APPENDIX I: PUBLIC CONSULTATION

Municipal Class Environmental Assessment Study: Mount Joy Creek Flood Mitigation

**APPENDIX J: MINUTES – AQUAFOR, TRCA, AND CITY
MEETING (SEPTEMBER 8, 2025 AND FEBRUARY 4, 2026)**

Mount Joy Creek Flood Mitigation EA Study

Alternative 4 – Open Channel Realignment

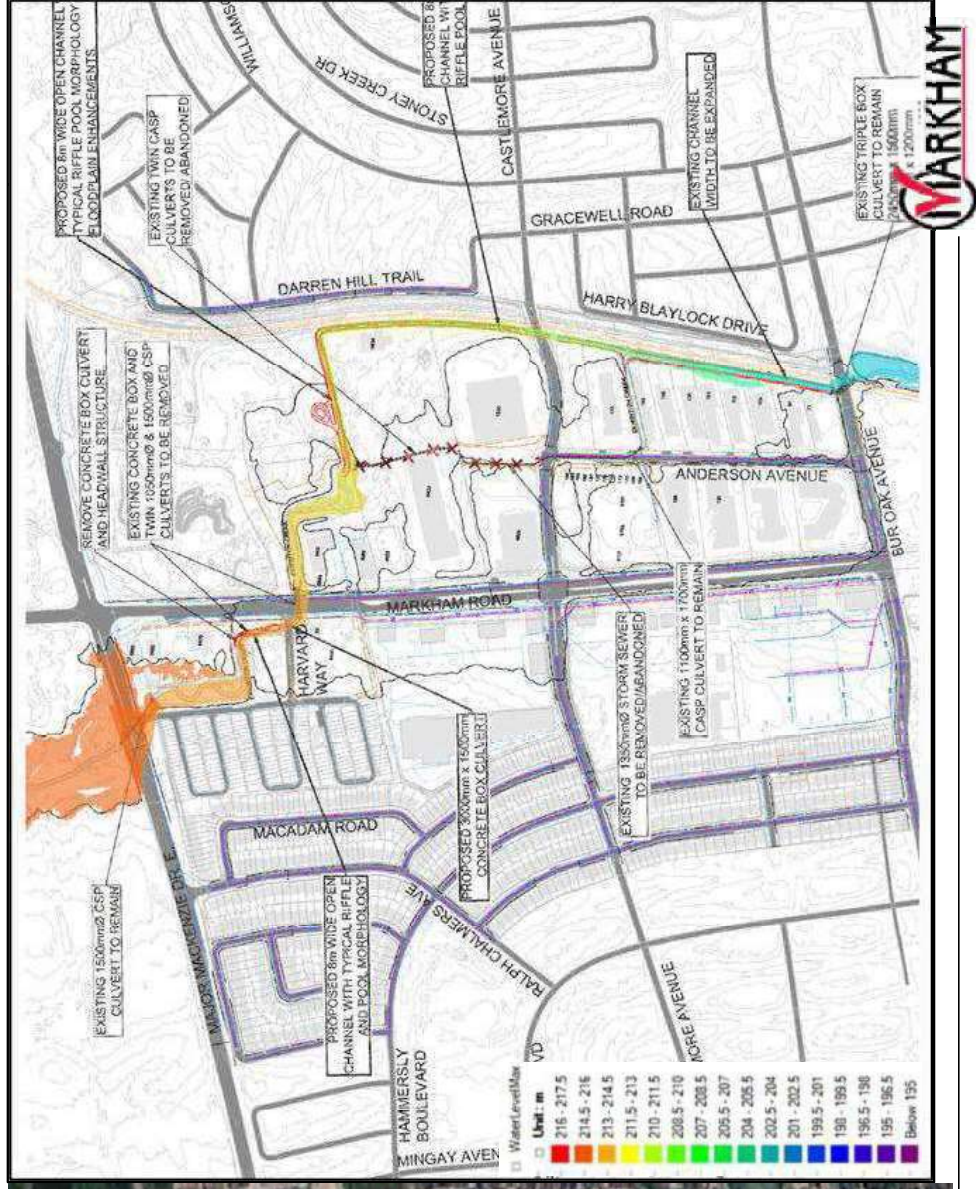
4	4. EA Alternatives Review/Status of EA (TK) – provided an overview of the proposed alternatives. (TK) – Described issues with Alternative #4. (IS) brings up that an ex-councilor has expressed at the PIC that this alternative is not wanted for safety concerns and other reasons. Relocated a flood hazard is not preferred, especially near a railway corridor (TK) continues with Alt 6 as it is similar to Alt 4. Explains that it can convey flows, though did not score well socially. (TK) – Alternative #7 identified as the preferred alternative. (TK) – Alternatives Evaluation Matrix presented and reviewed (SB) - what is the status of this file? What is the status of the EA? (IS) – 2nd PIC is September 10 th ; (EW) - brought to everyone's attention at the time that there was approval from Metrolinx that the channel could be moved closer to the Metrolinx property. (IS) yes it was discussed with Metrolinx, the 2nd consultation process found that there were additional issues and obstructions that it was not feasible and it was political and social pressure to not progress this method. (AH) EW is correct, Metrolinx

will allow this, though we would have to meet a standards and criteria which was found as an additional difficulty.

(MH) was involved with the secondary plan process and can confirm that, this alternative was set as the preferred alignment, though understands that this is no longer the case. Will have to take note of this so that more planning is done to assure the next secondary plan will help progress the design. This is an area that needs to progress with development. (IS) – just how the planning process unfolds, understand that this is an area that needs to move forward with development
